From: Hilary Ellis
Sent: 01 June 2021 16:57
To: 'Nolan, Sharon' <[REDACTED]>; Pickering, Jack
[REDACTED]
Cc: Craig Campbell [REDACTED]; Joely Norris
[REDACTED]
Subject: RE: A47 Improvement Schemes – Wansford

From: Pickering, Jack [REDACTED]
Sent: 31 March 2021 17:10
To: Nolan, Sharon [REDACTED]
Subject: A47 Improvement Schemes – Wansford

Thank you for the response to the Wittering Brook hydrology, River Nene hydrology and model review. We have addressed the comments below and would be grateful if these can be passed on to the E&R team.

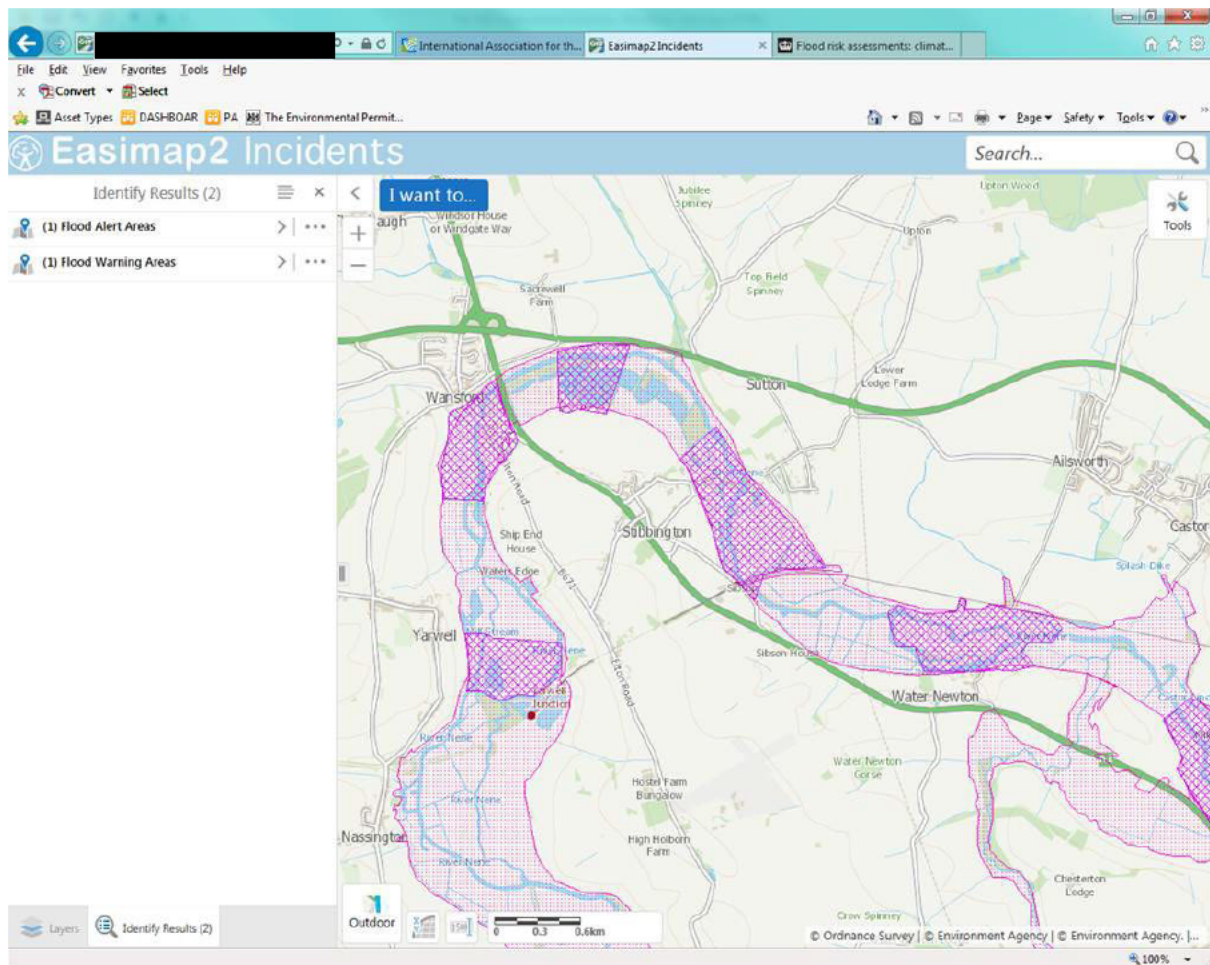
I have reviewed the FRA and have no further comments other than;
We would expect the FRA to be updated, as described, in line with the information provided in the email from Jack Pickering dated 31 March 2021, specifically in relation to floodplain compensation volumes. The FRA should include the floodplain compensation calculations and cross sections. The FRA in section 8.3.8 states that the scheme is not within an area that receives flood warnings/alerts but it is judging by the map below:

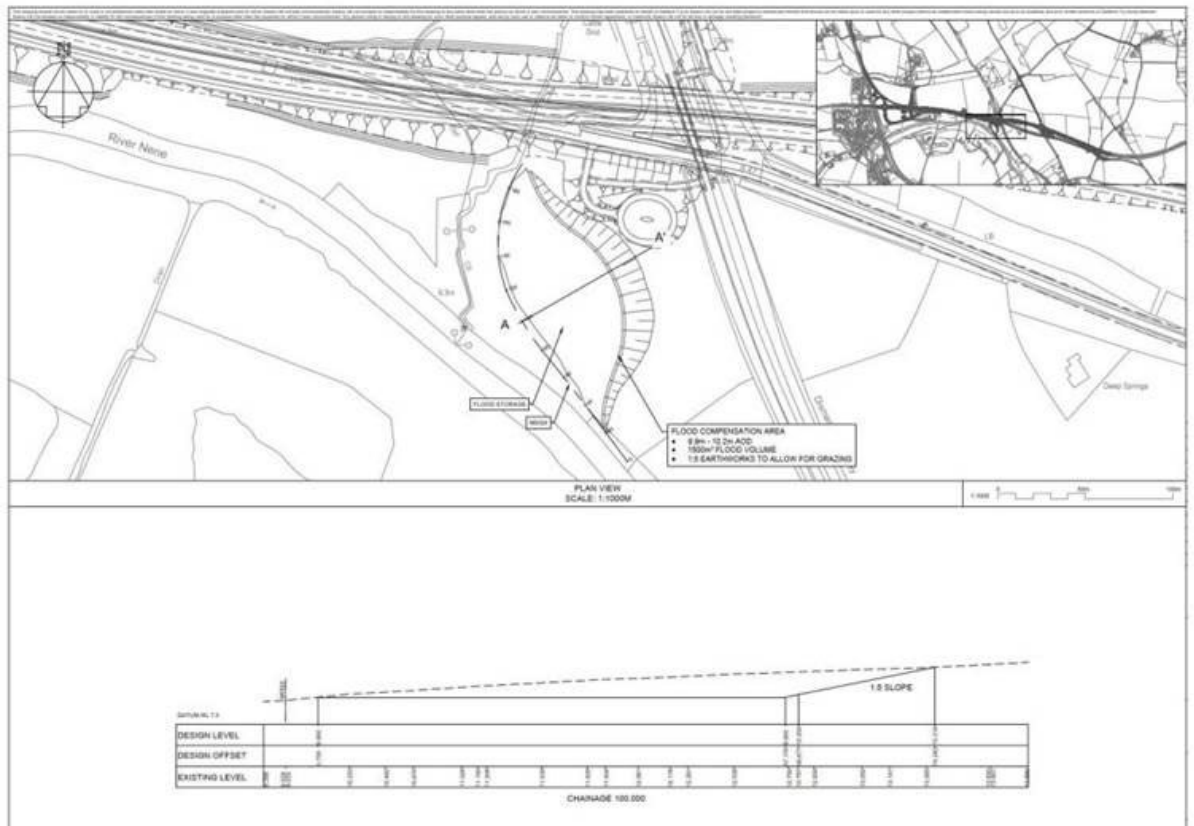
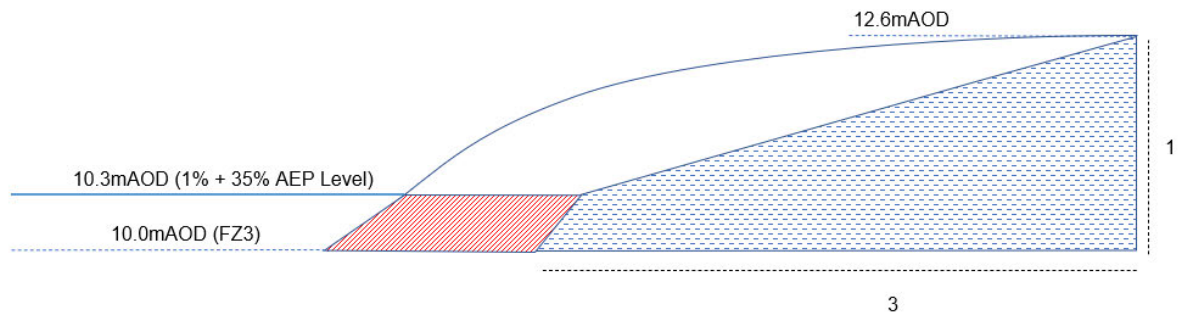
- *I have a couple of red comments regarding their choice of methodology, they've used ReFH2.3 whereas I think the FEH methods would be more suitable. Though the FEH flows are lower, they use actual observed data so we have a general preference for them. We can't normally justify using a method just because it produces higher flows, more clarification is*

required about this. As it is they seemed to have put a lot of effort into their FEH approach for the comparison which is also appreciated, these permeable ungauged catchments can be quite tricky to produce reliable flow estimates for. A hybrid method was chosen as the initial Wittering Brook hydrology to the model, however upon review it was decided to adopt the Refh2.3 design flows. The decision to use the higher RefH2 inflows was used to inform a conservative design level for the structures design.

- The model has been re-run using the WINFAP hydrology by adopting a hybrid method to scale the ReFH2.3 hydrographs. See attached for flood depth maps for the baseline/option scenarios plus detriment mapping for all design events. The predicted noticeable difference between the hydrology is the variation in flood depths across the Wittering Brook floodplain. The WINFAP hydrology (lower flows) has meant there is less betterment observed in the floodplain as a result of the proposed culvert. On average the predicted detriment across all design flood events is approximately 50mm. For lower order events (10-year) the 50mm detriment is predicted across a larger area of the floodplain however this is partly due to mesh elevation averaging. These areas are represented in the figures as the yellow and light green triangles with ranges of +/- 5cm. For higher order events, betterment is generally observed across more of the floodplain.

- Please see attached for our responses to the hydrology review.
